1.0 APPLICATION SUMMARY

The applicant is requesting to modify the PD as most recently modified under PRS 24-0634 to combine Blocks 5 and 9 into a larger block to allow for out parcels and multi-family residential dwellings including conventional and carriage house units.

APPLICATION NUMBER: PRS 26-0012

AGENCY REVIEW COMMENT SHEET

2.4 Proposed Site Plan (partial provided below for size and orientation purposes. See Section 8.2 for full site plan)

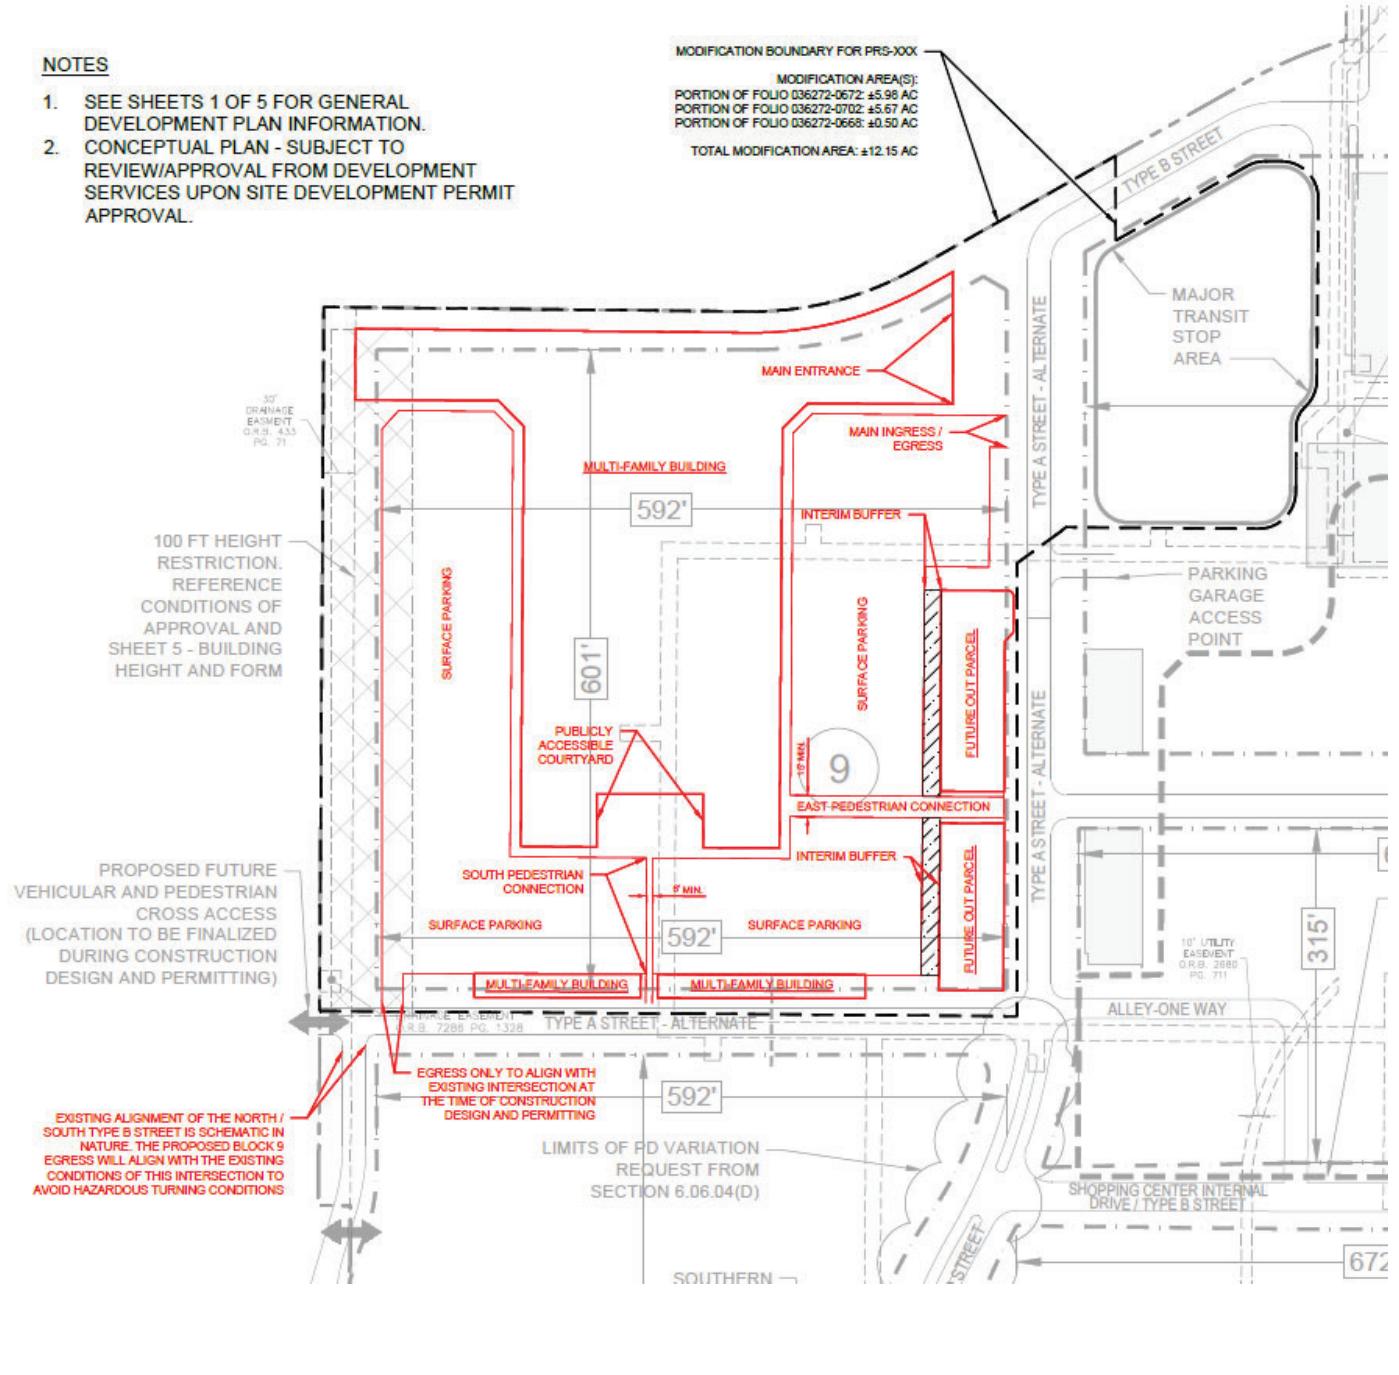
1. Remove note #2 on sheet 7 regarding the plan being "conceptual."

8.2 Proposed Site Plan (Full)

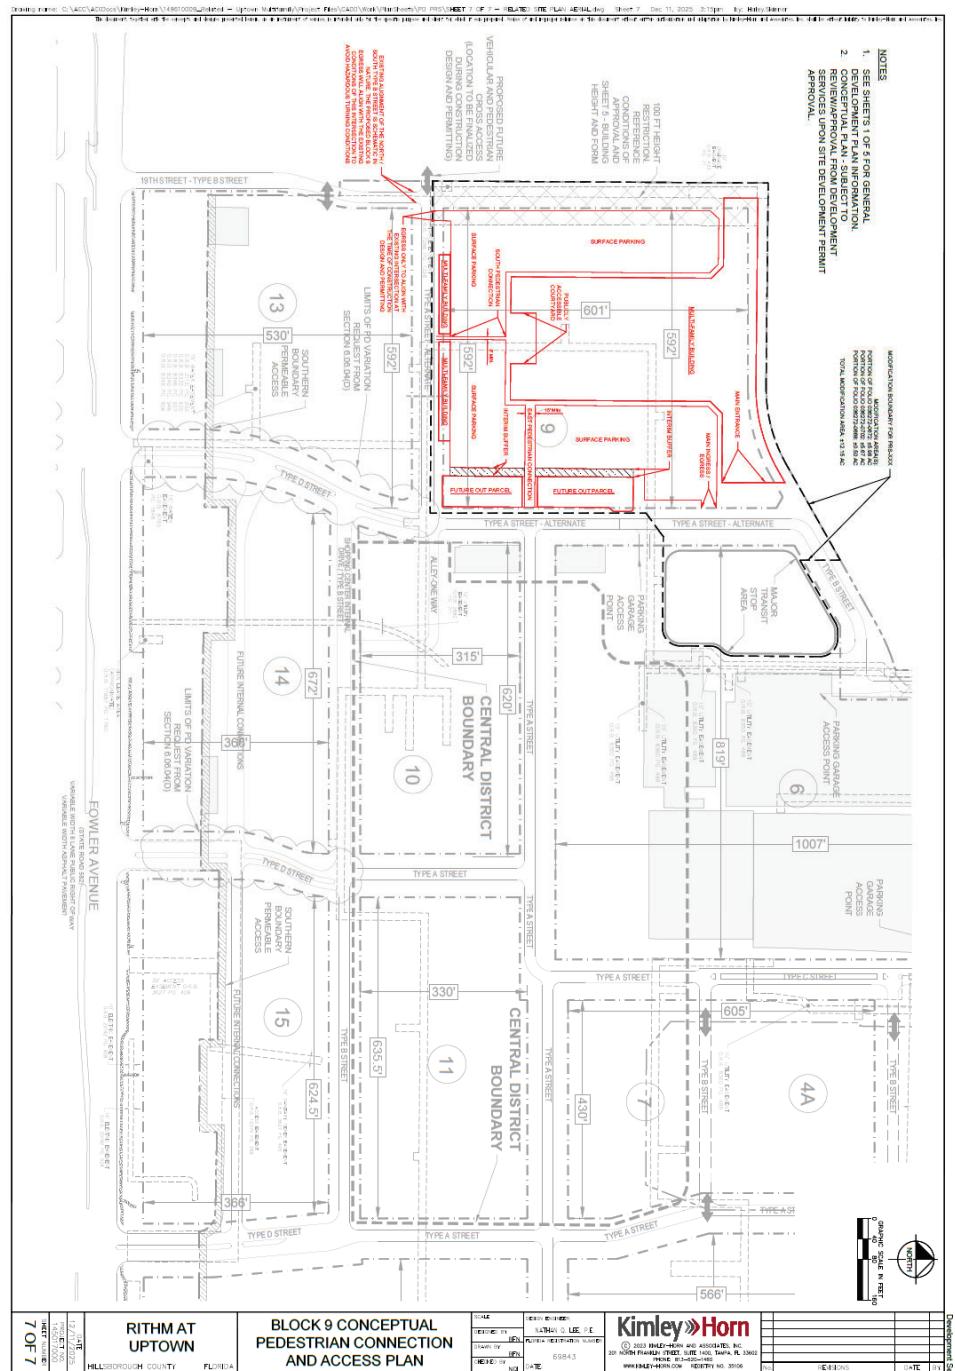
Sheet 7 of 7 includes a conceptual layout for a multi-family development and future outparcels with a Type A Street -Alternative section along the eastern and southern perimeter consistent with the proposed changes to the Condition of Approval #5.20 a. addressing the type and timing of construction of said street.

- h. The development of Block 9 shall be substantially similar to the layout set forth on Sheet 7 of 7.
- i. Development of Block 9 shall comply with the requirements of Conditions 5.5, 5.6, 5.12, 5.13, and 5.14.
